JAMES CITY SERVICE AUTHORITY

MEMORANDUM

Subject: SP-0104-2015 Williamsburg Landing Woodhaven Expansion

PLAT SHOWING JCSA UTILITY EASEMENT DEDICATED BY WILLIAMSBURG LANDING, INC. AND EXTINGUISHMENT BY JAMES CITY SERVICE AUTHORITY

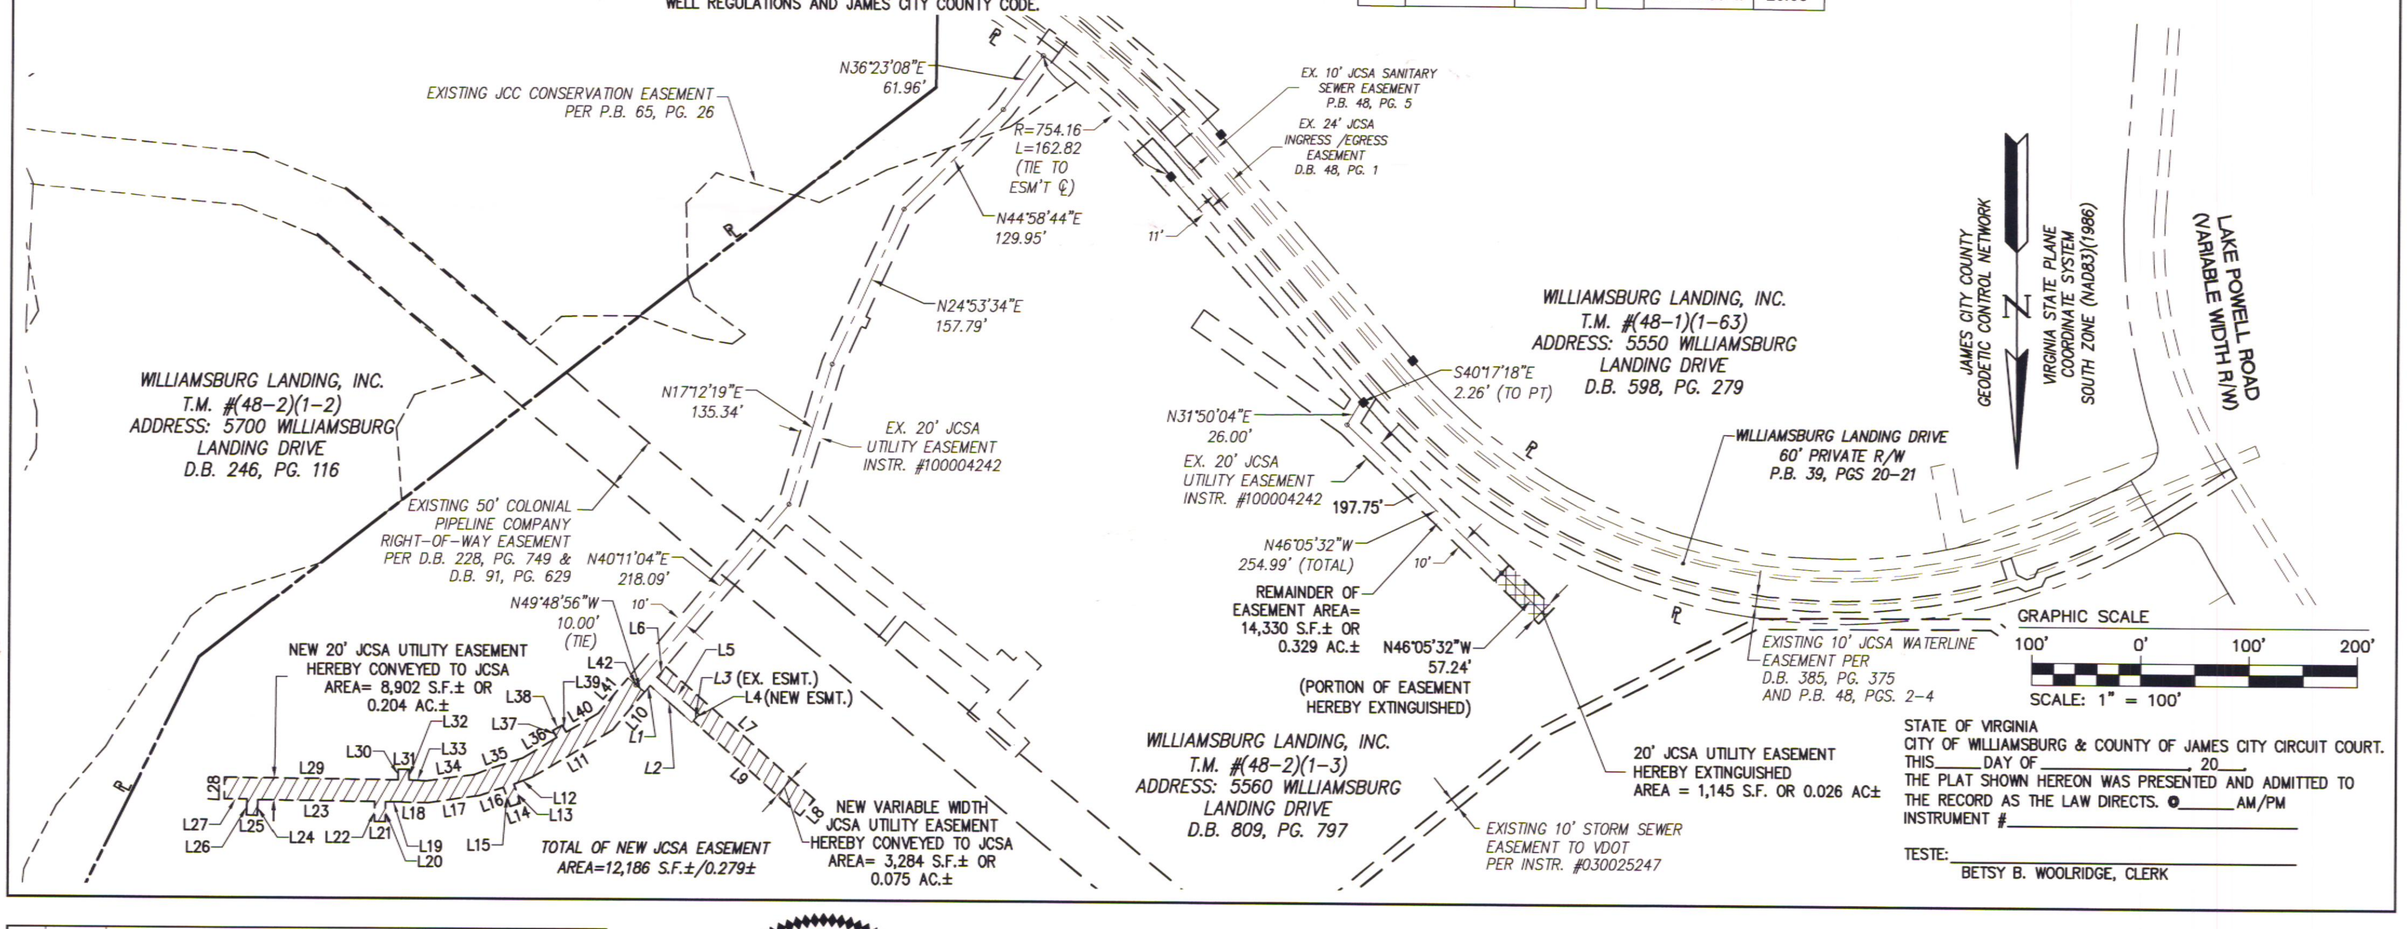
2. Was the plat showing JCSA Utility Easements (attached) ever recorded? If these easements were recorded, show and label the easements on the plan sheets. Portions of these easements may be required to be extinguished. Extinguishing easements shall be done prior to plan approval.

21. The JCSA sewer easement shown shall be labeled with recordation reference provided. Part of this sewer easement was to be extinguished (see attached plat). Was this easement plat recorded? If not label the easement per previous easement plat that was to have been recorded. The sewer manhole appears to have never been relocated and the sewer main was not shortened. Please verify. Determine how to correct sewer easement situation.
